Consultants Advice				
To: Ms Suzanne Debelak			Date: 28/04/2026	
Company: A W Edwards			Consultants Advice No: 002	
Email: s.debelak@awedwards.com.au			File/Ref No: 380926-51HuntingwoodDr-LoteCA-MOD-RevD	
Subject: Impact on Fire Engineering & FSS – MOD 1 Rev 3			Project Address: 51 Huntingwood Dr, Huntingwood, NSW 2148	
Issued by: Christopher Koch			Project No: 380926	
Distribution:				
To:	Cc:	Company:	Person:	Email:
☒	☐	A W Edwards	Riley Barns Stefanie Rodic	rbarns@awedwards.com.au srodic@awedwards.com.au

It is understood that as part of a review of the existing building design, a redesign is proposed which will result in the original ten (10) shells being reduced to five (5) shells. It is noted that as part of this modification, Shell B will consist of two (2) data halls instead of being split up into two separate shells. Based on this the proposed modification is similar in footprint to the previous modification which was assessed and since been withdrawn. The below sections outline the high-level review of the proposed design and the impact on the existing fire safety strategy for the building.

Lote Consulting has been engaged by A W Edwards to undertake an initial fire saf

Figure 2-1: Current Syd3 site layout, approved SSDA

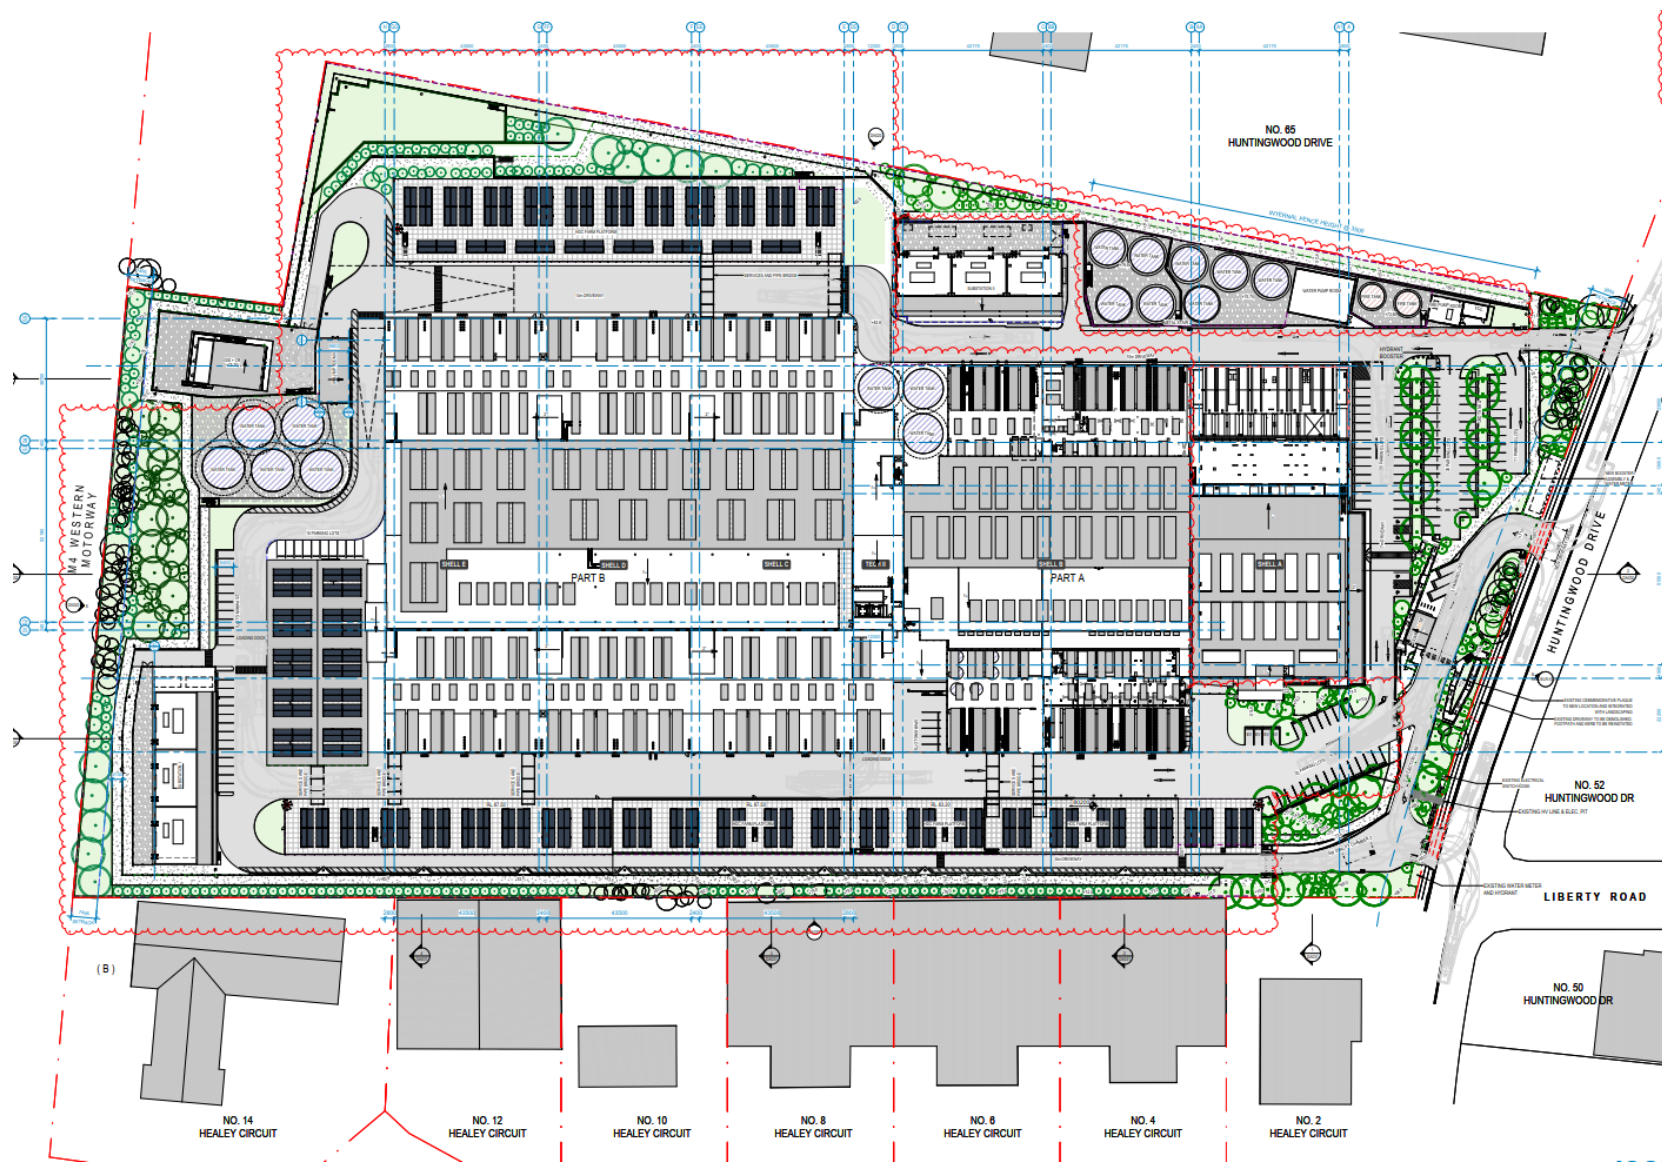
The revised layout modifies the spatial arrangement of data halls, generators, substations, and associated infrastructure.

While no new hazard sources are introduced, the updated configuration may affect:

- 1) Separation distances between critical infrastructure elements.
- 2) Exposure of adjacent assets to radiant heat and flame impingement.
- 3) In rack batteries separation distances in the data halls.
- 4) Fire brigade access pathways and operational clearances.

Separation distances adopted in the approved FSS should be reviewed and validated against the revised layout to confirm the continued compliance with applicable criteria.
